Corrigendum-02Amendments and reply/clarification to bidders queries

**Name of work:** Design, Construction, Testing, Commissioning and Validation of BSL-3 Laboratory, BSL-2 Laboratory and Animal Facility (EPC Mode) including operation & maintenance at Institute of Advance Virology, Thonnakkal, Thiruvananthapuram

Tender no. HITES/IDS/IAV-BSL/23/28 dated 07.03.2024

DRAWING TITLE : ARCHITECTURAL DRAWING  
**GROUND FLOOR PLAN**  
**TENDER DRAWING - R1**

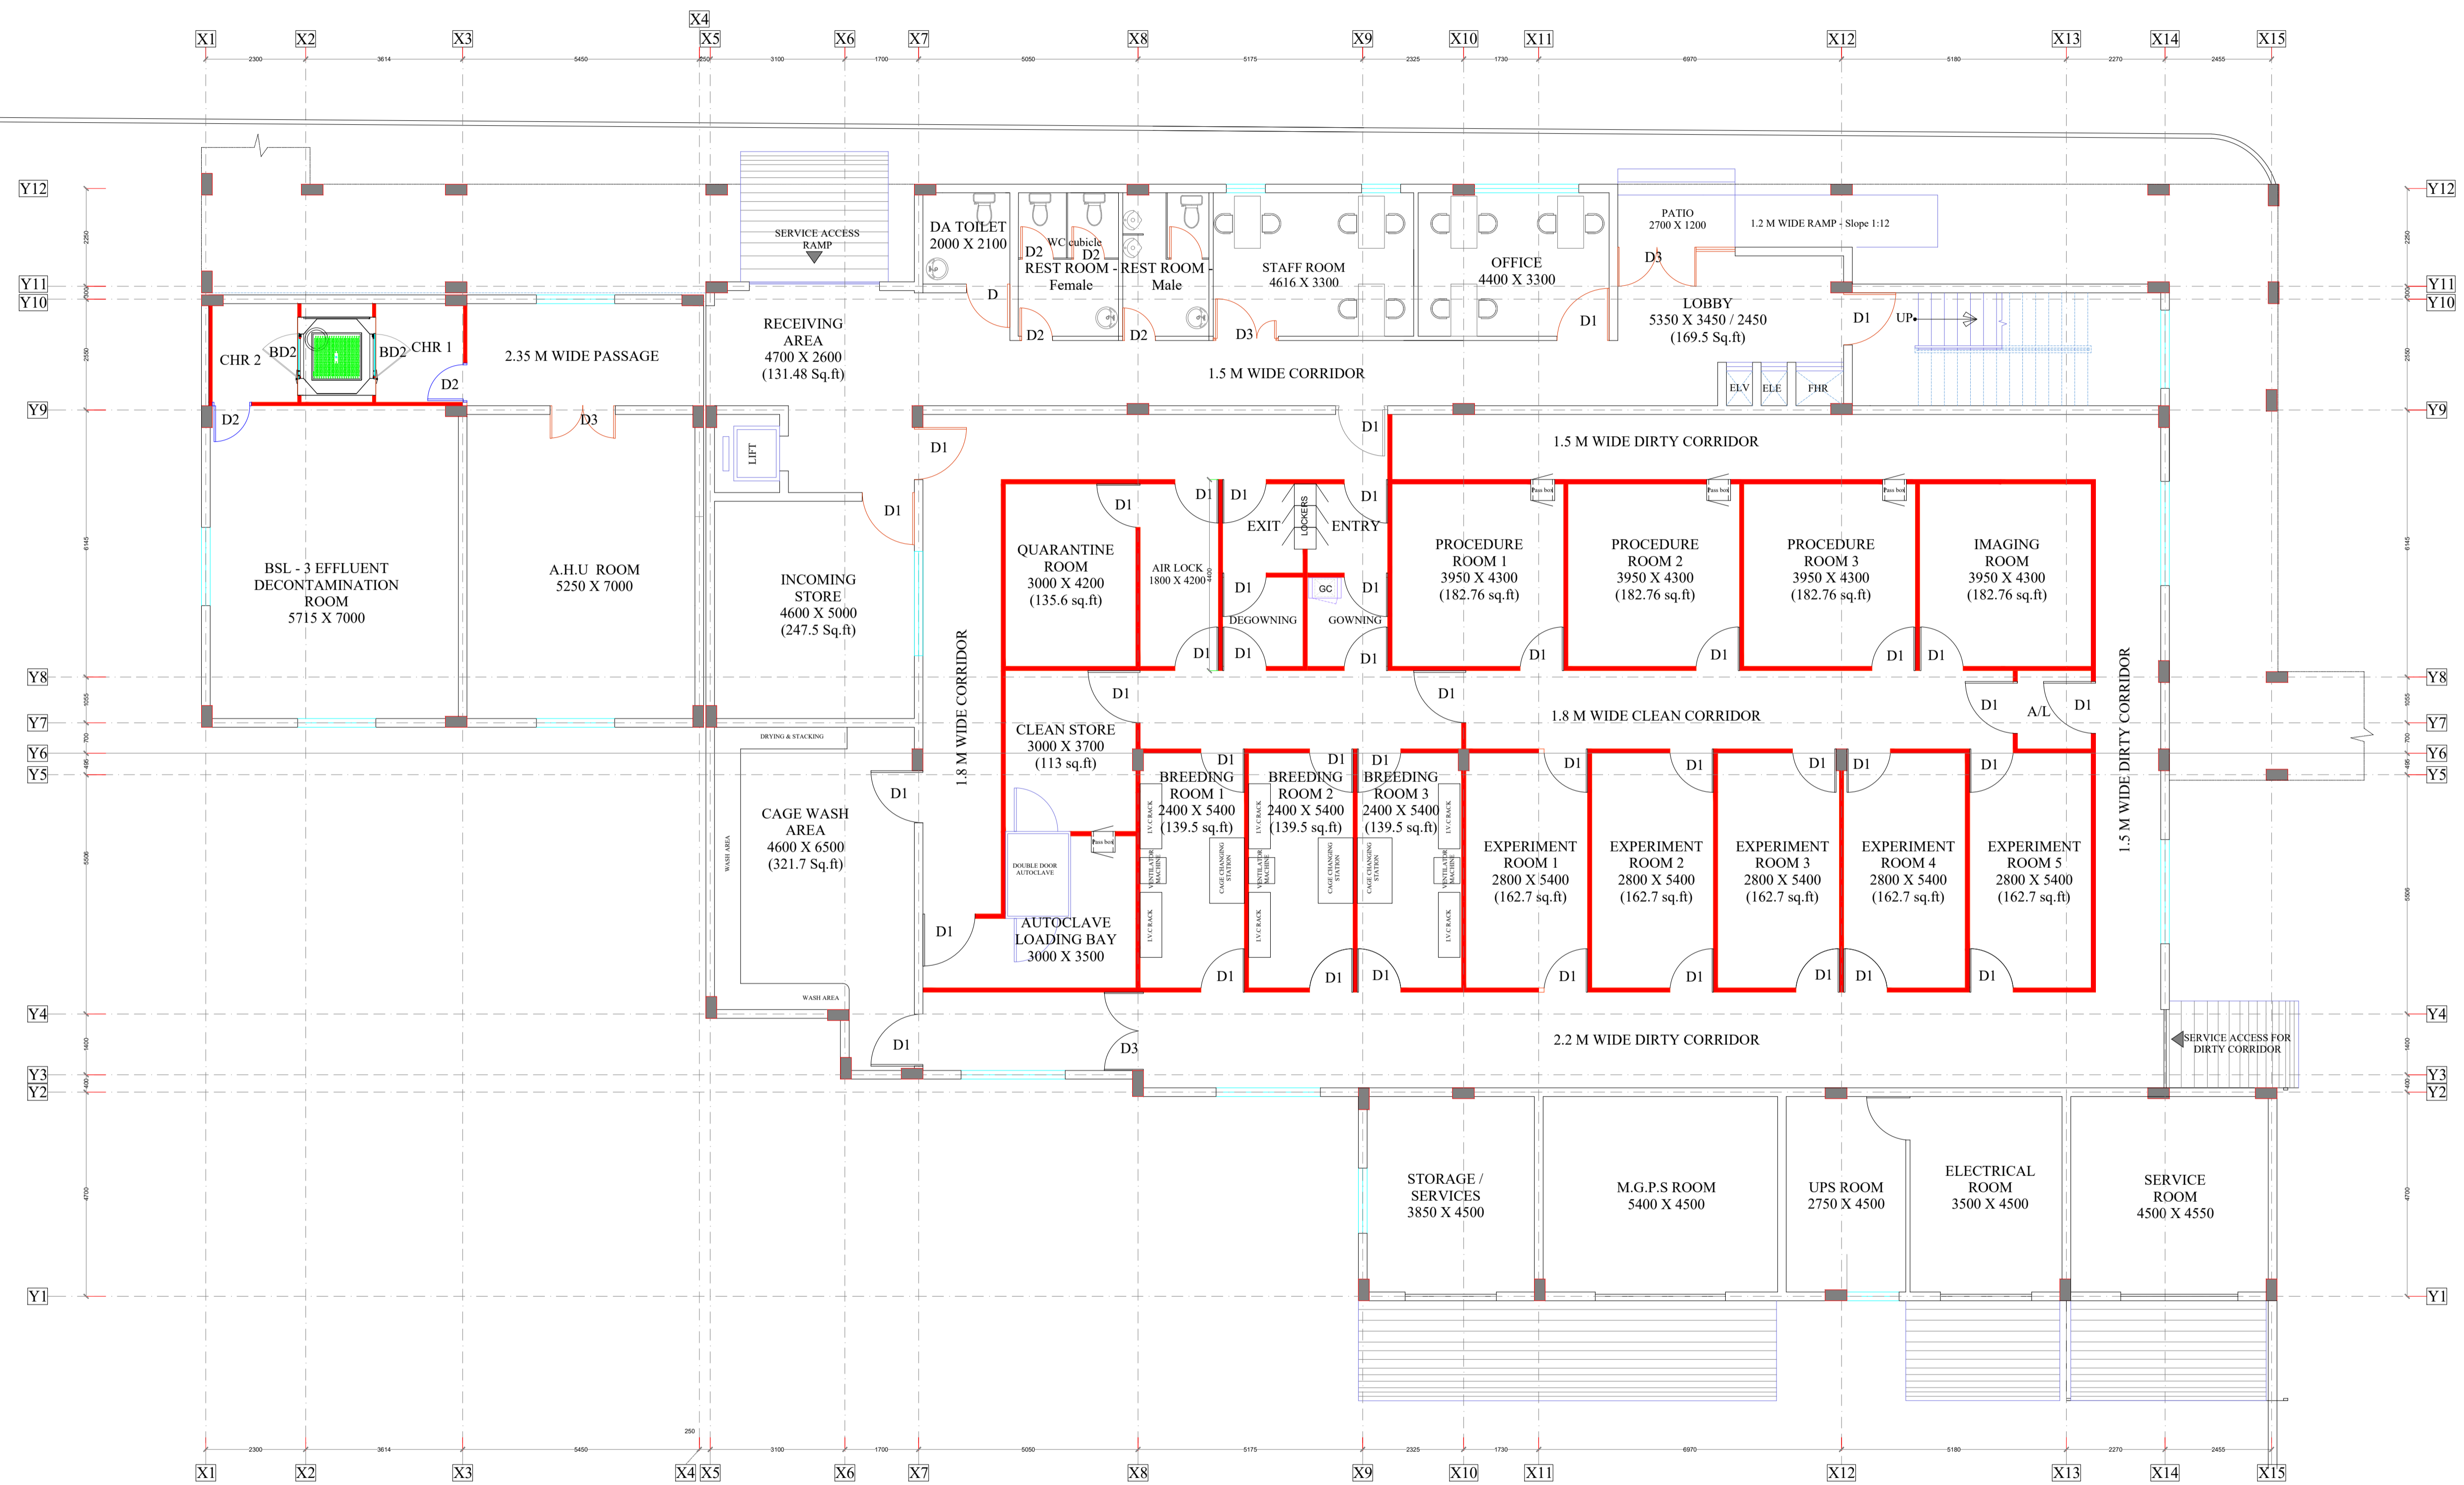
Sl. No.	Tender Reference	As per tender	Amended as
2	Volume-6 : Tender Drawings	Tender Drawings	<p>Following Revised (R1) Drawings are attached:</p> <p>HITES/IDD/GOK/BSL3/TNKL/2022-23/A-03,  HITES/IDD/GOK/BSL3/TNKL/2022-23/A-04  HITES/IDD/GOK/BSL3/TNKL/2022-23/A-05</p> <p>Bidders are requested to follow the above revised drawings. All other tender drawings provided in tender documents shall remain unchanged.</p>
3	Volume 1 NIT	Last Date & time of Submission of Bids online (Bid due date) :01.04.2024at 3.00 PM	Last Date & time of Submission of Bids online (Bid due date) : <b><u>15.04.2024 at 3.00 PM</u></b>
		Date & time of opening of Technical Bids through e-tender portal: 02.04.2024at 3.00 PM	Date & time of opening of Technical Bids through e-tender portal: <b><u>16.04.2024at 3.00 PM</u></b>

NO.	DATE	DESCRIPTION	DWN	CKD	APD
1.	18.03.24	AIR LOCK ADDED

DRAWING TITLE : ARCHITECTURAL DRAWING  
**FIRST FLOOR PLAN**  
 TENDER DRAWING - R1

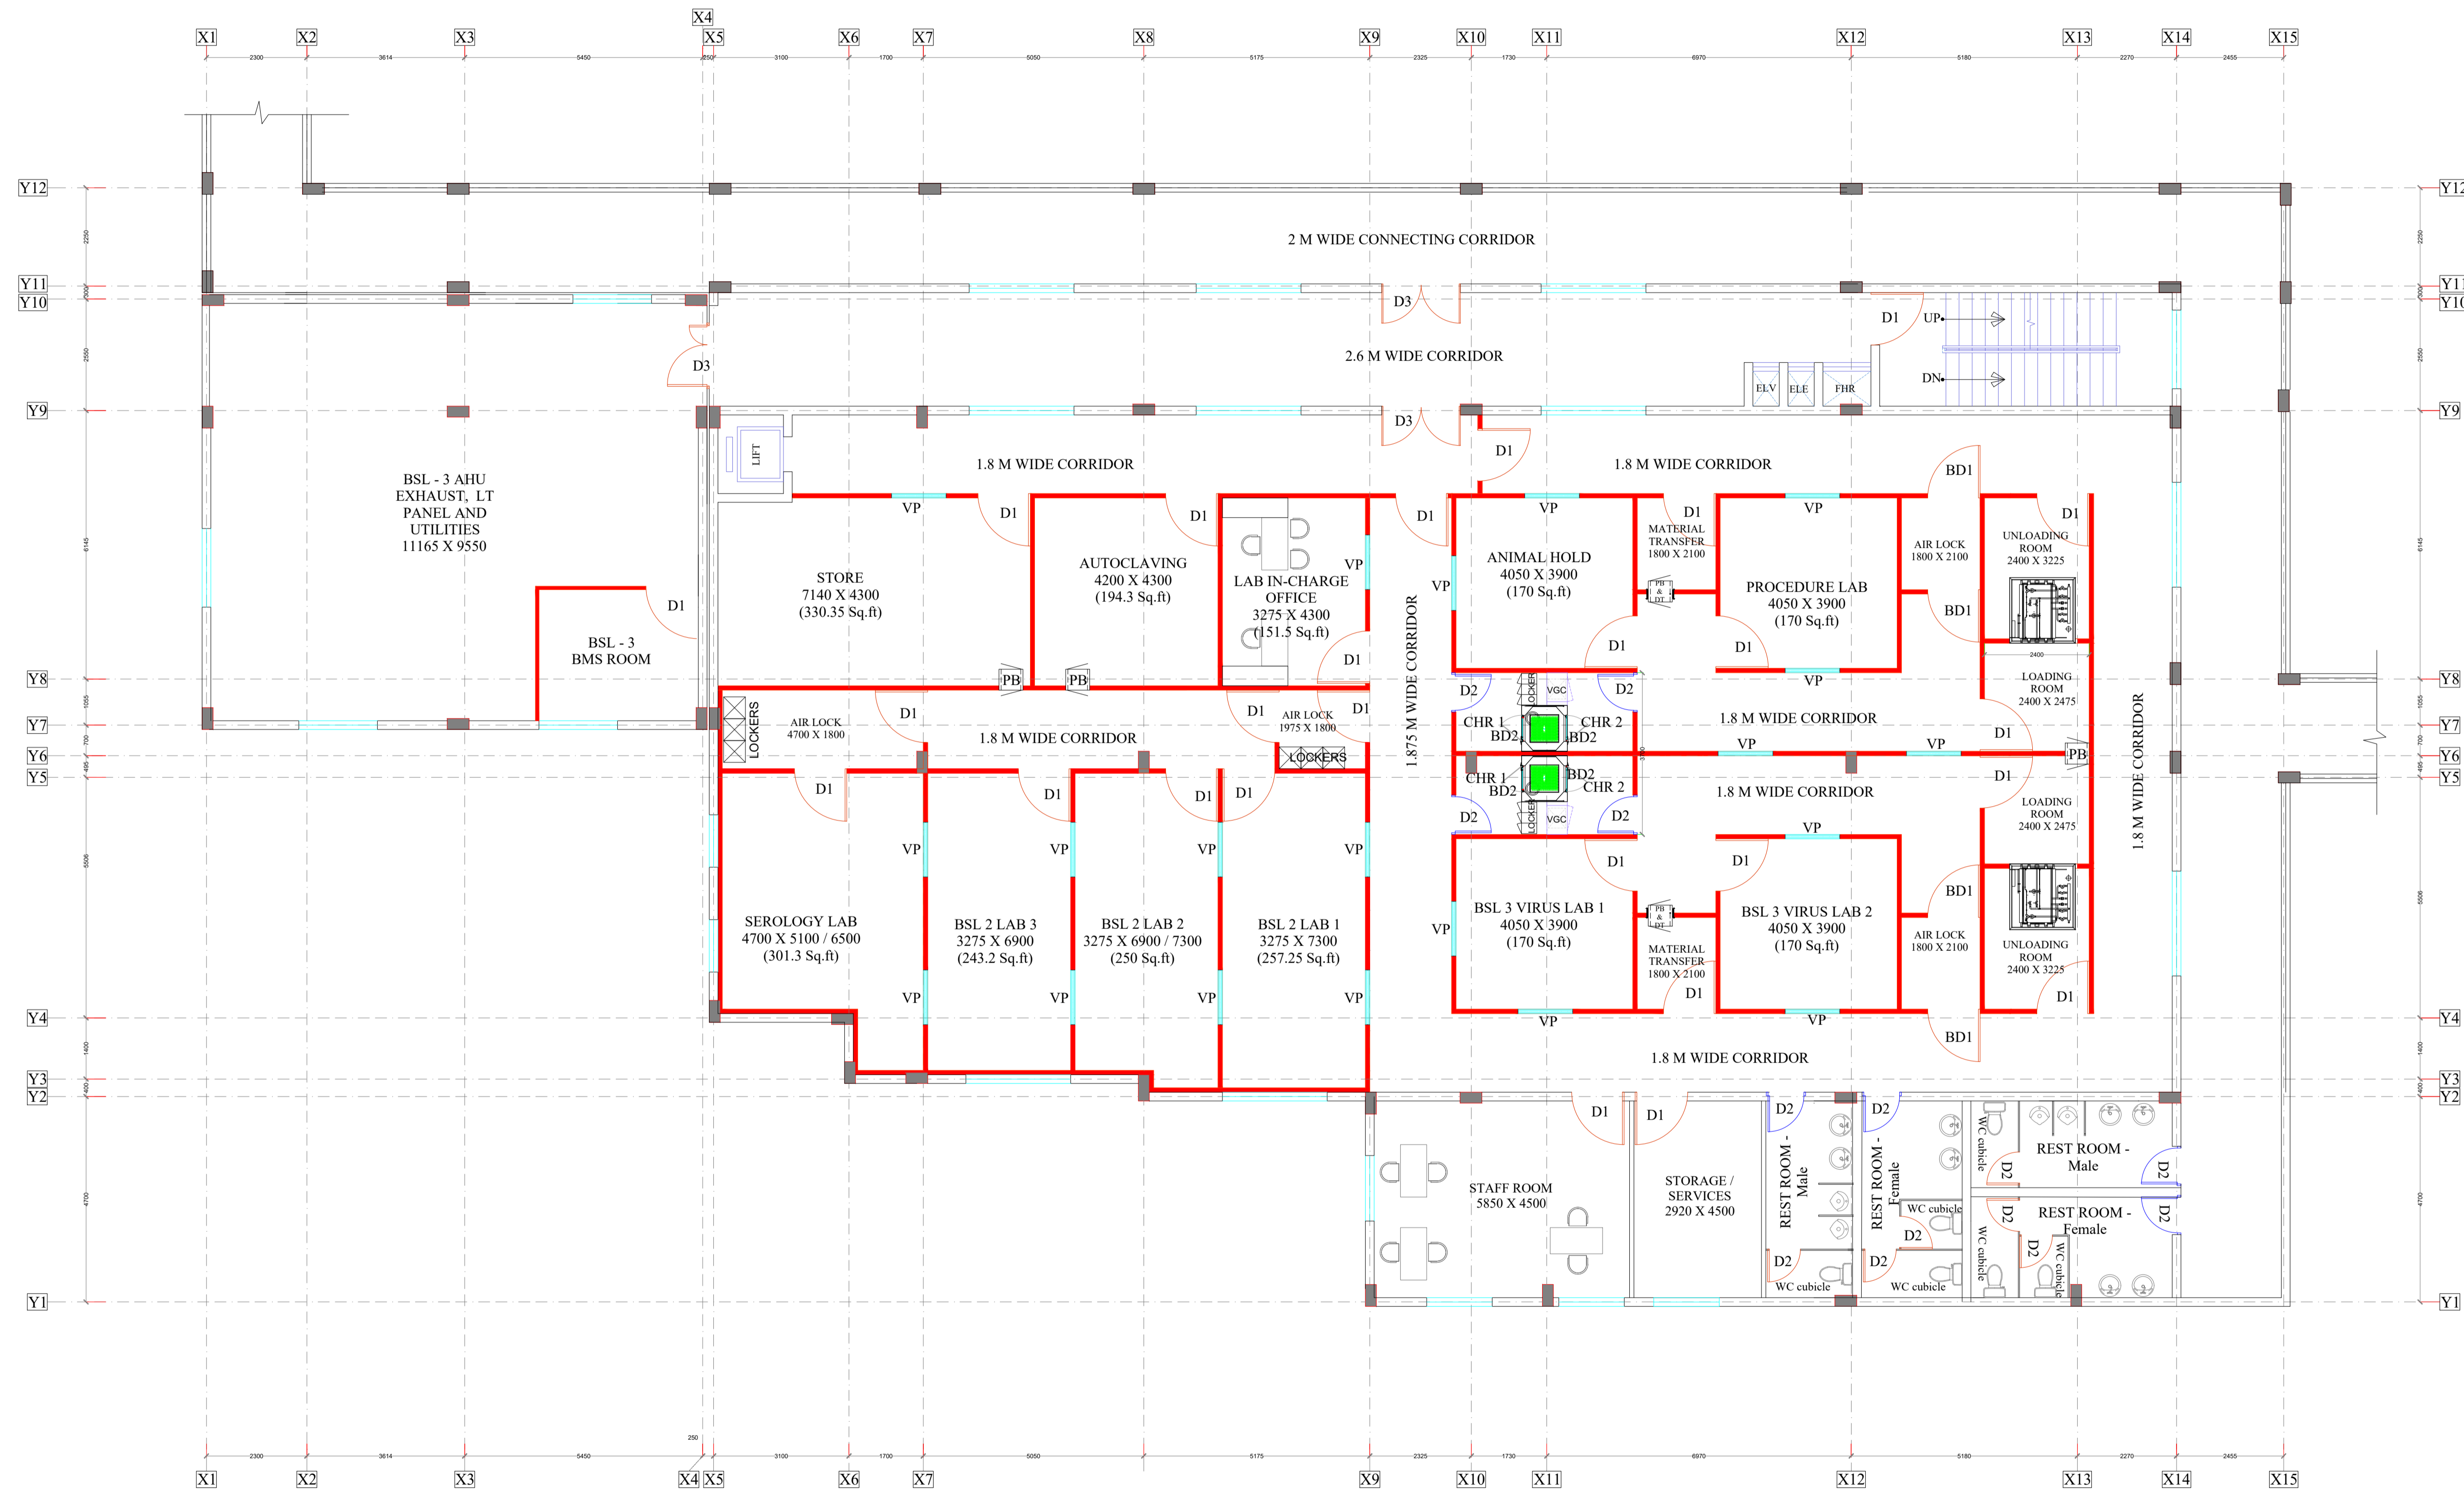
13	<p>Volume 5 - Technical Specification</p> <p>Section III - Technical Specification for HVAC &amp; Associated Works</p>	<p>HVAC Design - Please confirm false ceiling heights to be considered</p>	<p>Refer revised Drawing No. HITES/IDD/GOK/BSL3/TNKL/2022-23/A-05 issued with this Corrgendum-02</p>
14	<p>Volume 5 - Technical Specification</p> <p>Section III - Technical Specification for HVAC &amp; Associated Works</p>	<p>HVAC Design - Please provide scientific equipment electrical load details or room wise equipment list.</p> <p>Please confirm whether supply of CO2, Compressed Air, Power, etc. for scientific equipment is in Bidders scope of works.</p>	<p>Tentative equipment layout already provided in tender drawings. Being an EPC contract, further detailing of works shall be done by the contractor and is in the scope of the contractor.</p> <p>Yes, supply of CO2, Compressed Air, Power, etc. for scientific equipment is in Bidders scope of works.</p>
